UN Regulation No. 44 (Child restraint systems)**Proposal for Supplement 14 to the 04 series of amendments
to UN Regulation No. 44 (Child restraint systems)****Submitted by the expert from France on behalf of the Technical Service
Group (TSG) ***

The text reproduced below was prepared by the expert from France on behalf of the Technical Services Group (TSG) on UN Regulation No. 44 to clarify the test protocol for positioning and securing the child restraint system on the vehicle. The modifications to the current text of UN Regulation are marked in bold for new characters.

Figures for the explanation of the measurement procedure

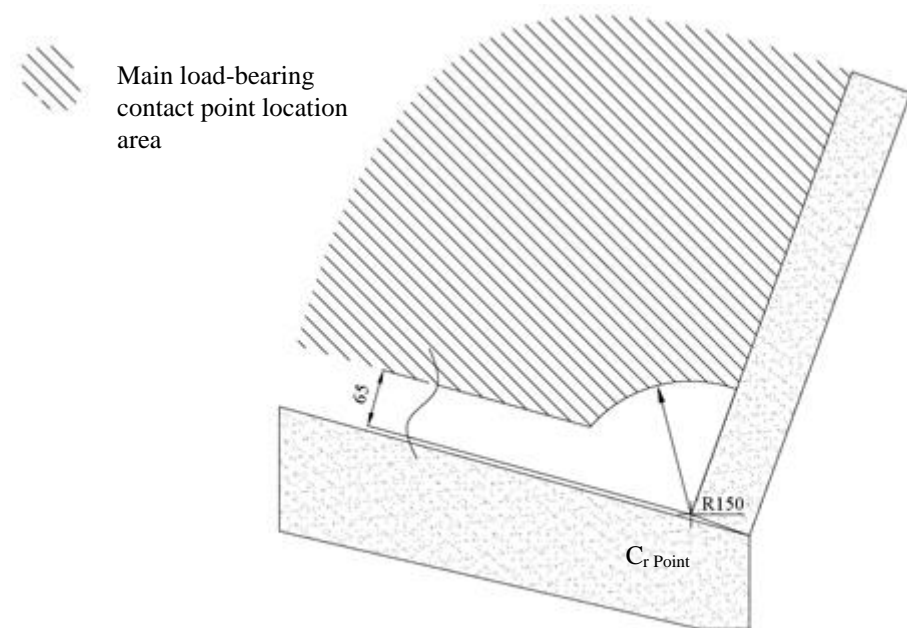
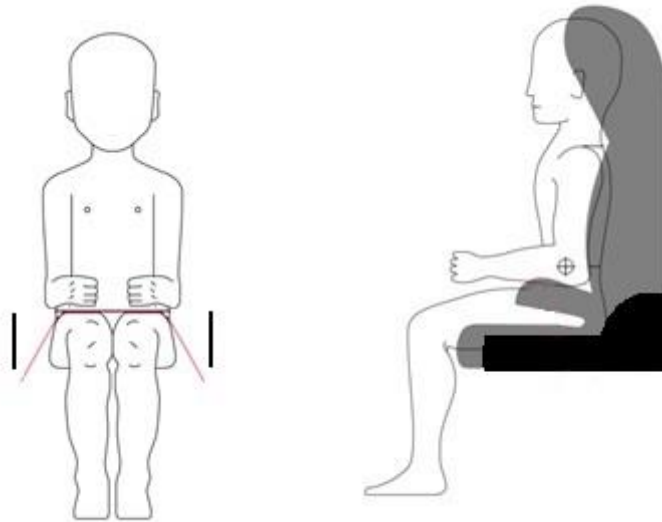
"6.1.8. Integral child restraint systems of the "universal" category, except ISOFIX universal child restraint systems, shall have a main load-bearing contact point, between the child restraint and the webbing of the adult safety-belt. This point shall not be less than **a radius of 150mm** from the Cr axis when measured with the child restraint **as indicated in figures below**, on the dynamic test bench installed in accordance with Annex 21 to this Regulation without a dummy.

Non-integral child restraint systems of the "universal" category, shall have a main load-bearing contact point, between the child restraint and the webbing of the adult safety-belt. This point shall not be less than 65 mm vertically above the test bench cushion and not be less than **a radius of 150mm** from the Cr axis when measured with the child restraint **as indicated in figures below**, on the dynamic test bench installed in accordance with Annex 21 to this Regulation without a dummy.

The check shall be done at both sides of the CRS and along a longitudinal plane parallel to the median plane of the CRS.

Figures of Strapped child

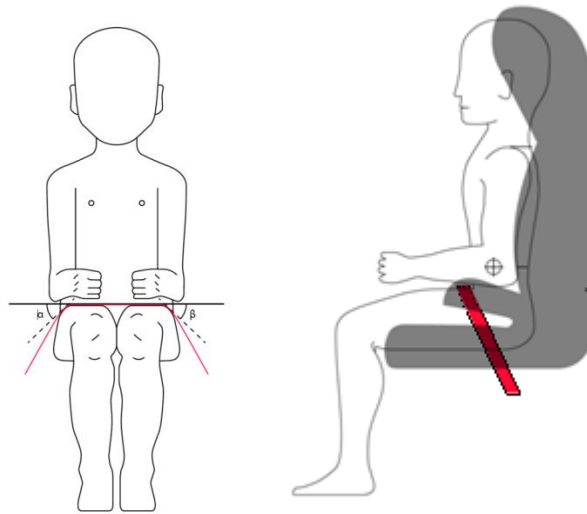
"6.2.2. All restraint devices utilizing a "lap strap" shall positively guide the "lap strap" **equilateral** on both sides to ensure that the **load** transmitted by the "lap strap" are transmitted through the pelvis. The assembly shall not subject weak parts of the child's body (abdomen, crotch, etc.) to excessive stresses. "

In the case of booster cushions and booster seats , the lap portion of the adult seat belt shall be positively guided **equilateral** on both sides to ensure that the loads are transmitted by the adult lap belt are transmitted through the pelvis. The positive guidance of loads over the pelvis shall be realised from the moment that the child is installed; the lap belt shall pass over the top of the thigh, just touching the fold with the pelvis. The angles α and β between the tangent line in which the belt touches the thighs and the horizontal shall be greater than 10° ."
